4901 Dorset Ave. Somerset H.D.
35136 2010 HAWP

March 9, 2010
Staff Item
Anne Fothergill
4901 Dorset Avenue
Non-Contributing Resource--Somerset Historic District

In January 2010 the HPC approved the relocation of part of the retaining wall along the front driveway for accessibility to this house. The applicants are now proposing to move the rest of the retaining wall 24 inches. Photos and plans are attached. Staff is requesting that the HPC allow this change to be approved at the staff level.

A PROP. SITE PLAN
 2 1/16"=1'-0"

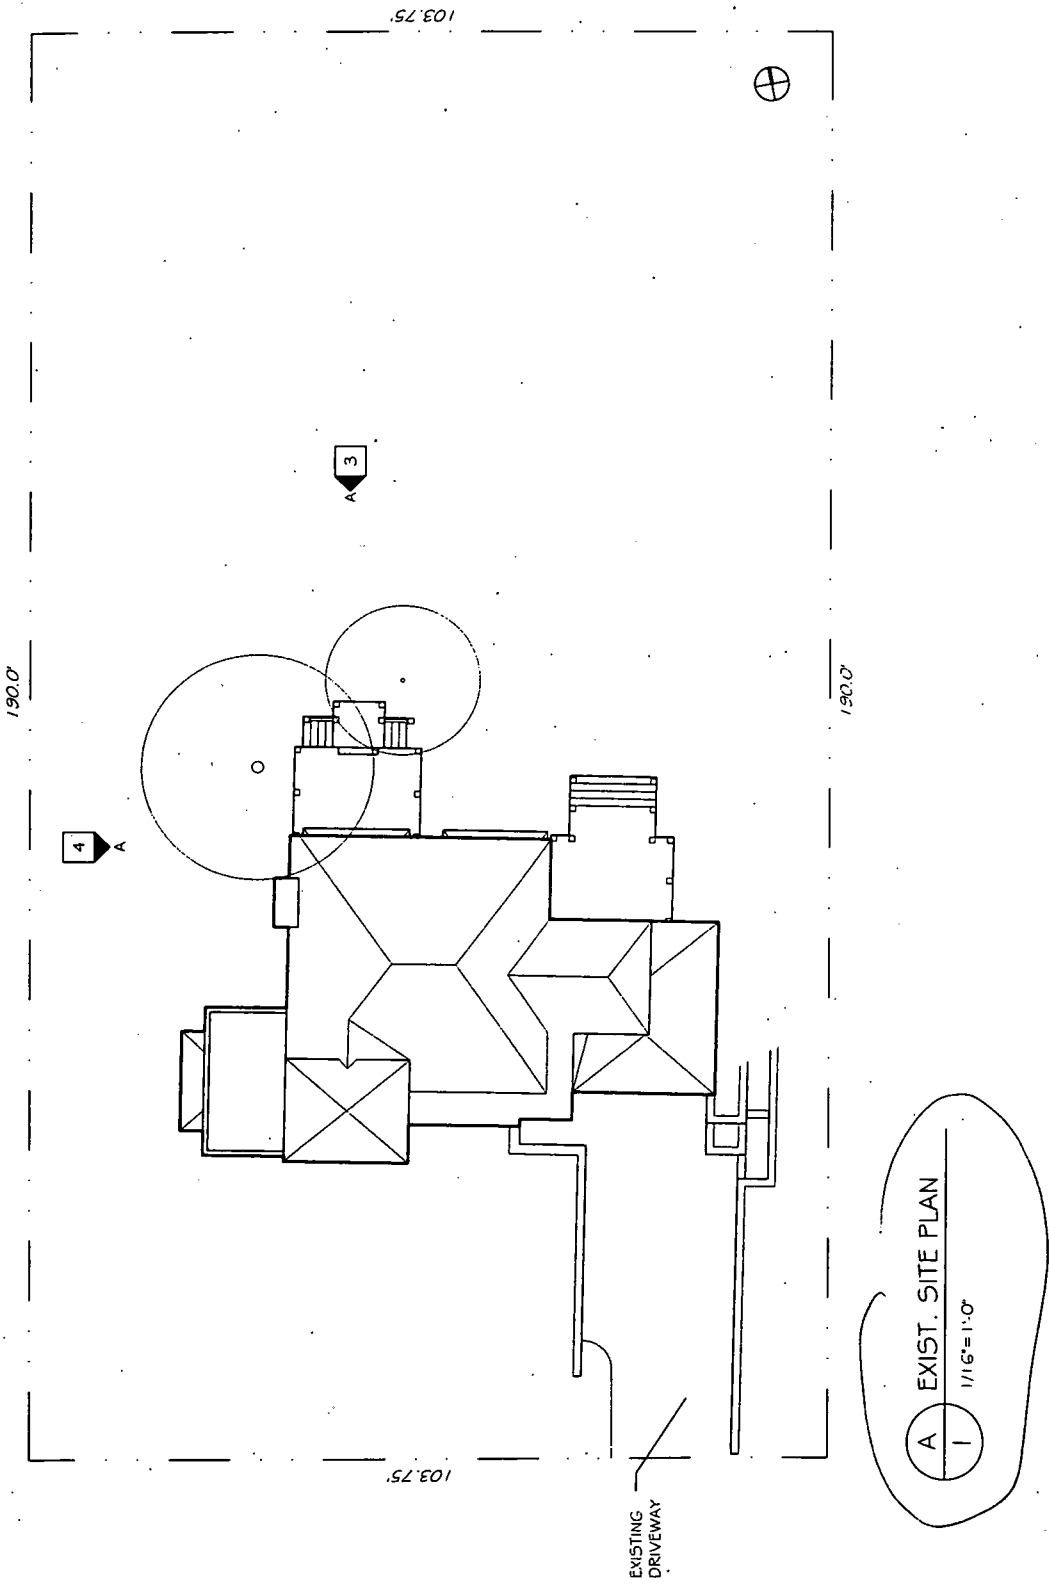
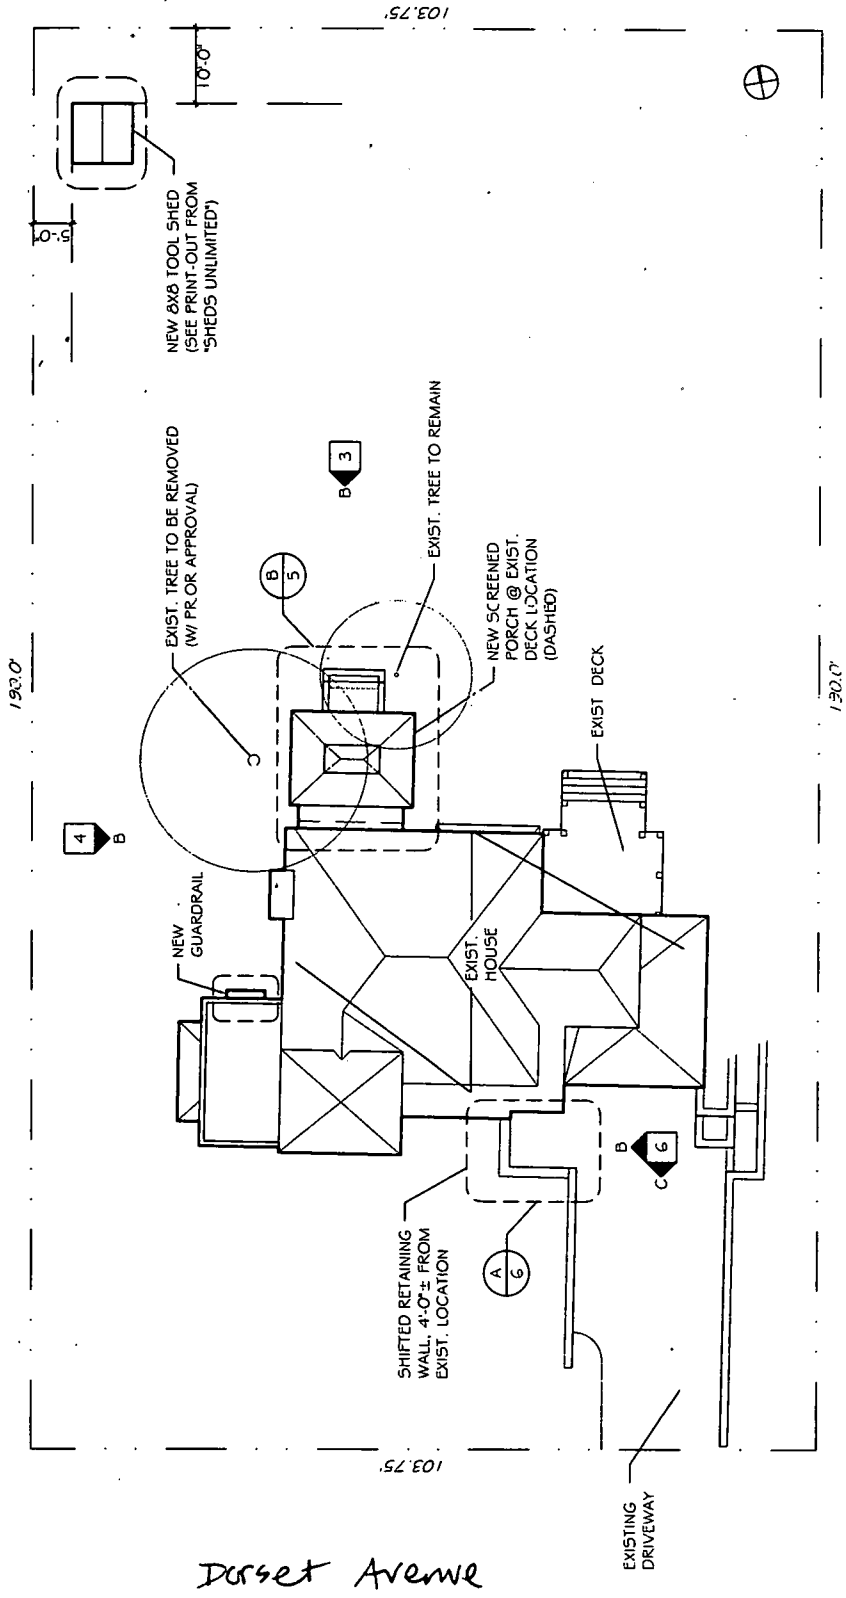
I request that the Historic Preservation Commission amend our HAWP to allow us to widen the entire remaining length of the driveway (that portion not already subject to the HAWP), by moving the existing retaining wall 24 inches to the west. We will use the same materials in the relocated retaining wall as are presently used in the wall.

Proposed

A
 EXIST. SITE PLAN
 1/16" = 1'-0"
 NOT RESCALE @ 8 1/2" x 11"

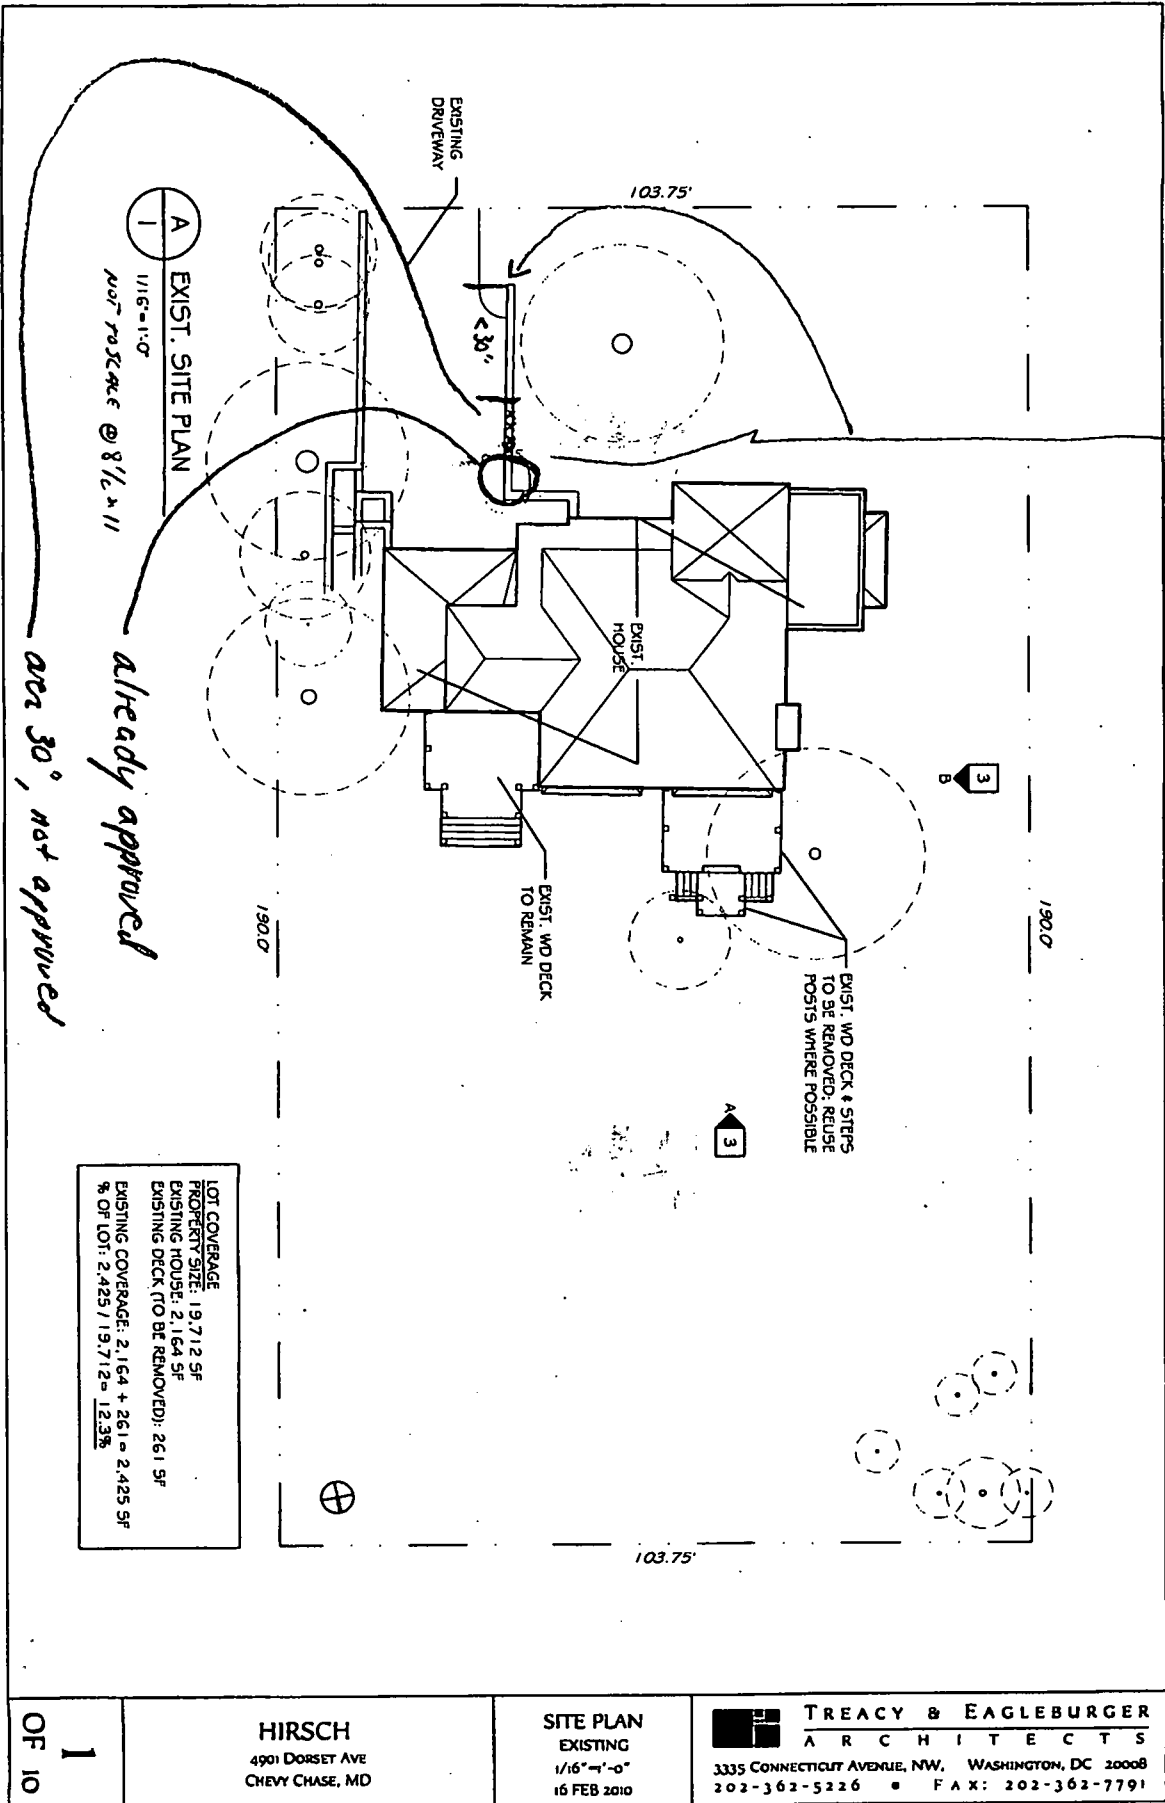
I would like to amend our permit to widen the entire driveway by 24 inches, along the entire length of the retaining wall. The first 16.4 feet of the retaining wall, measured from the top of the driveway, is less than 30 inches in height. I understood that an HAWP may not be needed to move that section, because no County building permit is required to build a retaining wall under 30 inches. Could you tell me if an HAWP is required to move that section of wall 24 inches, maintaining all the same materials?

There is a remaining approximately 7.8 foot section of retaining wall that is over 30 inches in height (in addition to the four to five foot section for which we already have a HAWP to move). Could you tell me if I need to go through the full HAWP process with another public hearing to move the 7.8 foot section of retaining wall 24 inches to the west? Or, is there a summary procedure for the staff or Commission to grant a go ahead for non-material changes to an existing permit?

Seeking information about moving retaining wall 24 inches. 164 feet of the wall is under 30" high. 7.8 feet is over.

already approved
over 30", not approved

A PLAN @ DRIVEWAY
1/8" = 1'-0"

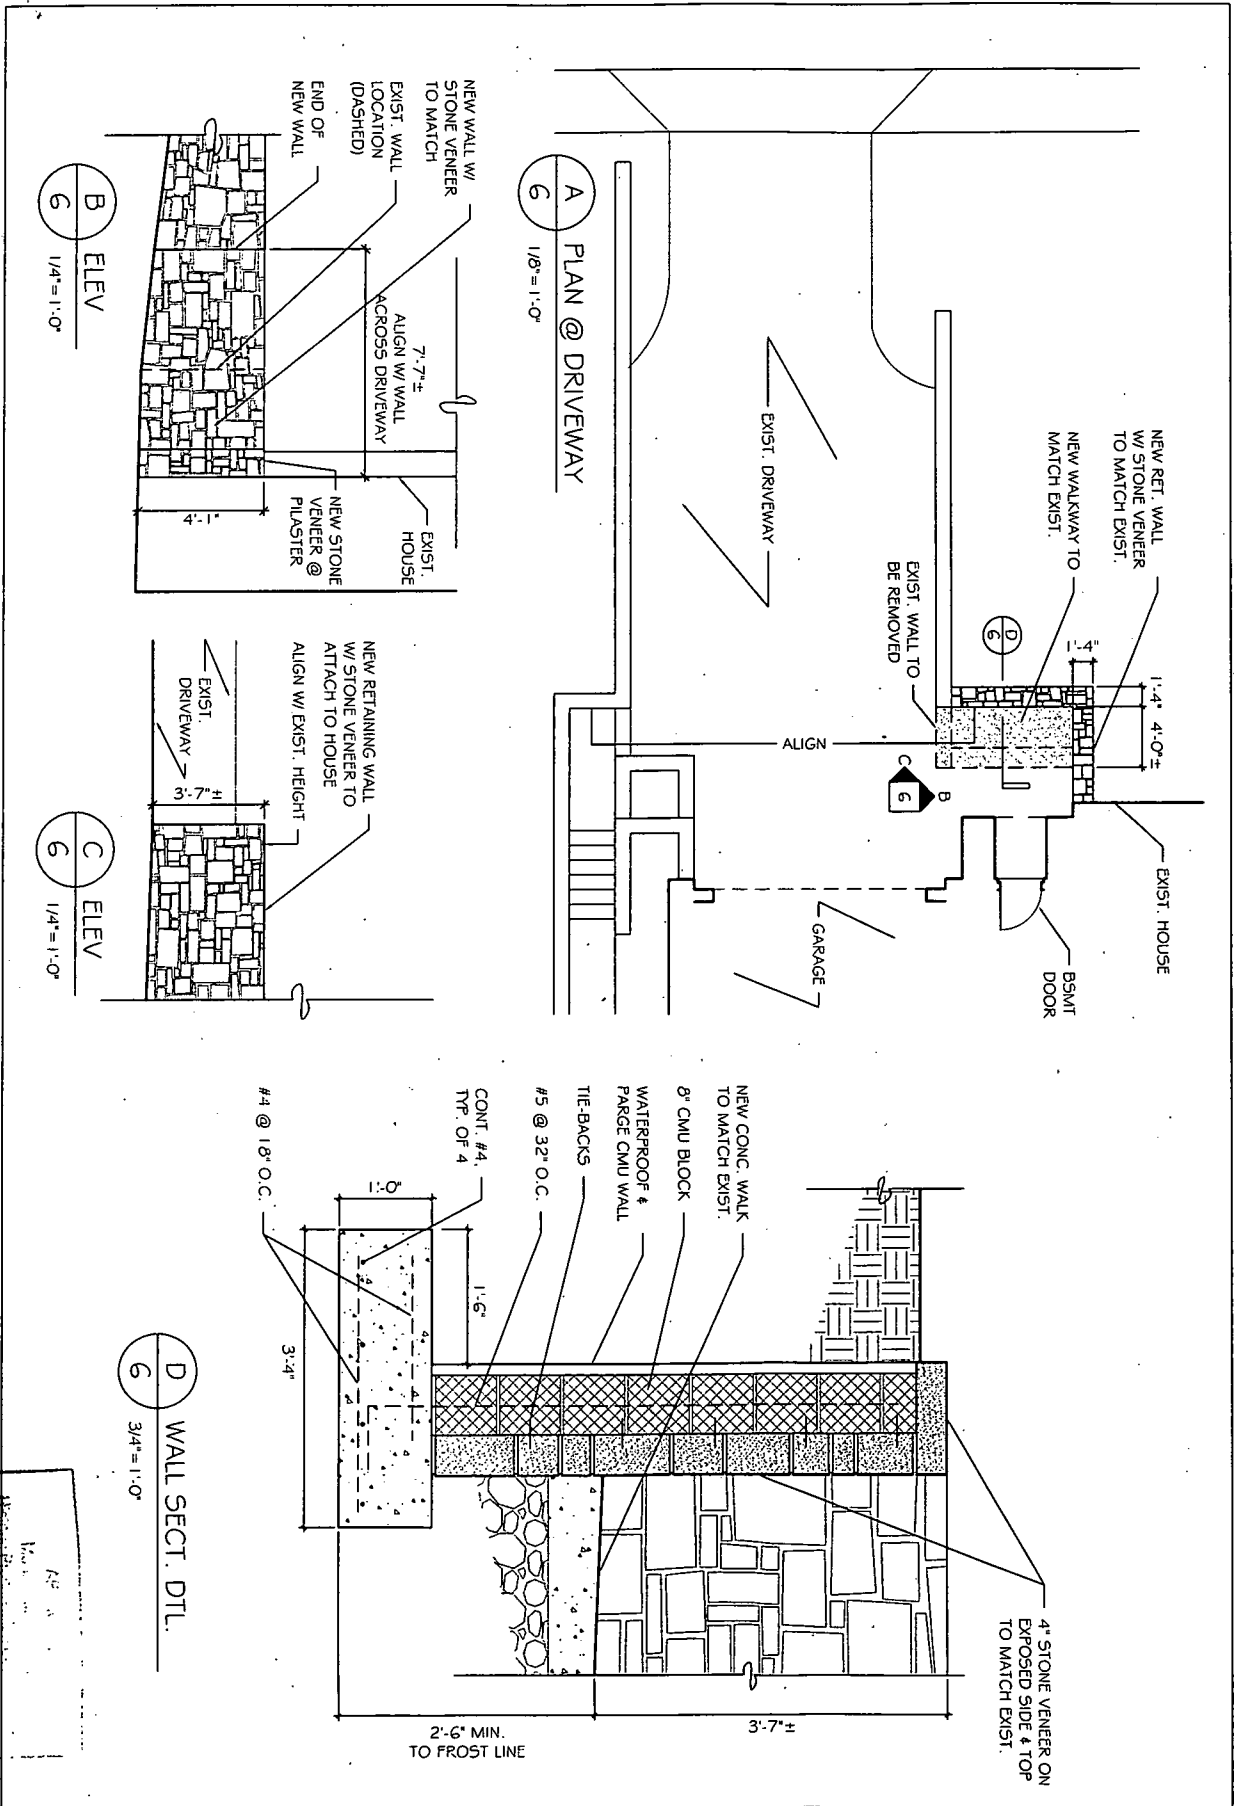
- 1) Install an 8' x 8' wood shed in the northwest rear corner of the property
- 2) Widen the front driveway and walkway and rebuild existing 4' tall driveway retaining wall to provide more accessibility
- 3) Remove a rear deck and construct a one-story screened porch with a metal roof and skylight and wood stairs to grade
- 4) Install a new wood operable window in existing rear window opening and install iron guardrail with wood brackets
